ADDENDUM NO. 2

PROJECT: FAIRFIELD MIDDLE SCHOOL, COURT YARDS, STOREFRONT WINDOWS &
DOORS INSTALLATION
IFB 2223-10

DATE: April 20, 2023

Revised Scope of Work

PARTIAL STOREFRONT ELEVATION

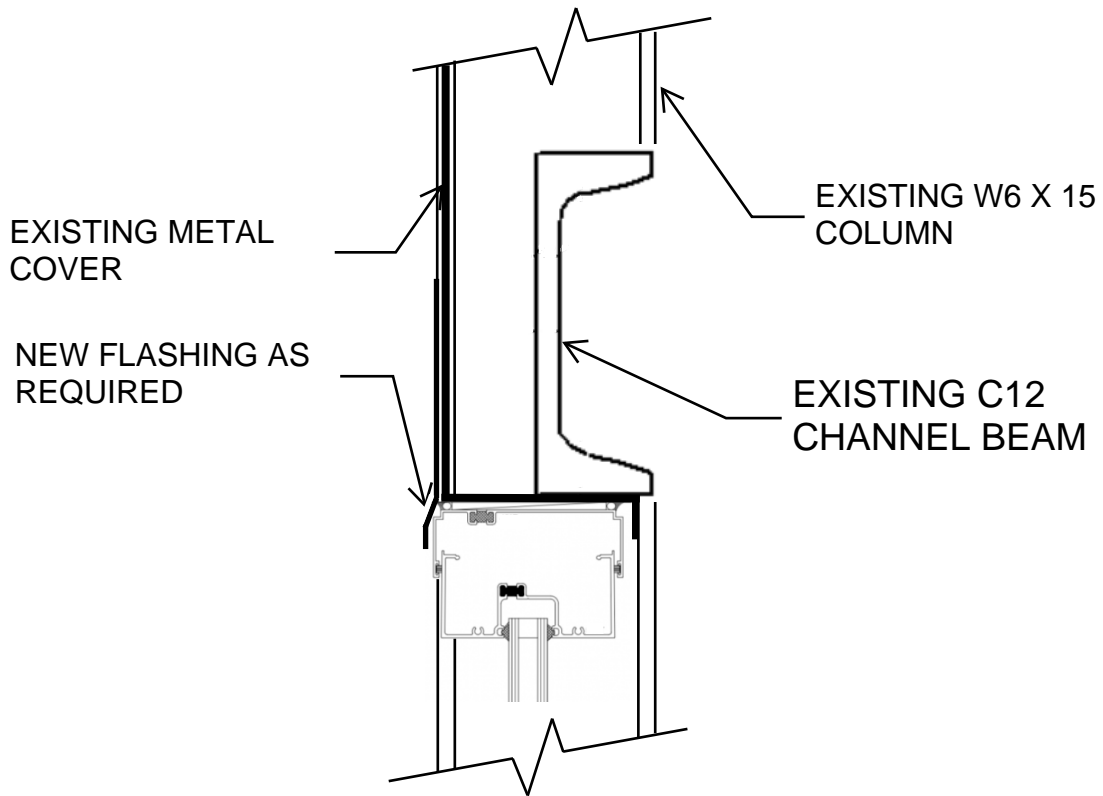
The new storefront windows and doors (3'0" x 7'0") shall have 1" double-pane, low e, tinted (color selected by Owner), tempered safety glass consisting of two panes of ¼" glass with insulative gas in a sealed compartment between the panes. Window and door frames shall be 2" x 4 ½" Commercial Storefront aluminum, finished to match the school's front entrance (dark bronze) as designed and manufactured by Kawneer or equal. Opaque fillers shall be 1" insulated panels finished to match the frames. The lower pane height should be such it will allow a horizontal frame member at 34" to 36" AFF.

1" THICK INSULATED
PANEL COLOR TO MATCH
WINDOW FRAME
